42390P16990

Remarks

Objection to the Specification

FIGURE 13

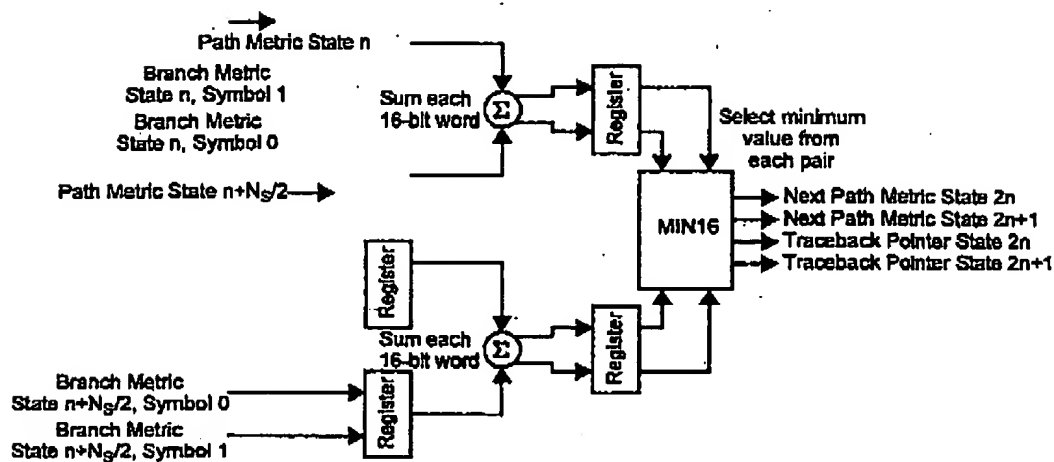
Please remove the paragraphs on page 13, starting with line 7 and continuing through line 11 that reference Figs. 13-16. Further, please remove the reference, under BRIEF DESCRIPTION OF THE DRAWINGS, to Figs. 13-16 found on page 5, starting with line 1 and continuing to line 8. Along with removing the reference to Figs. 13-16 from the specification, also see the attached marking of these figures as cancelled and labeled as 'Annotated Sheet' per 37 CFR 1.121(d)(1).
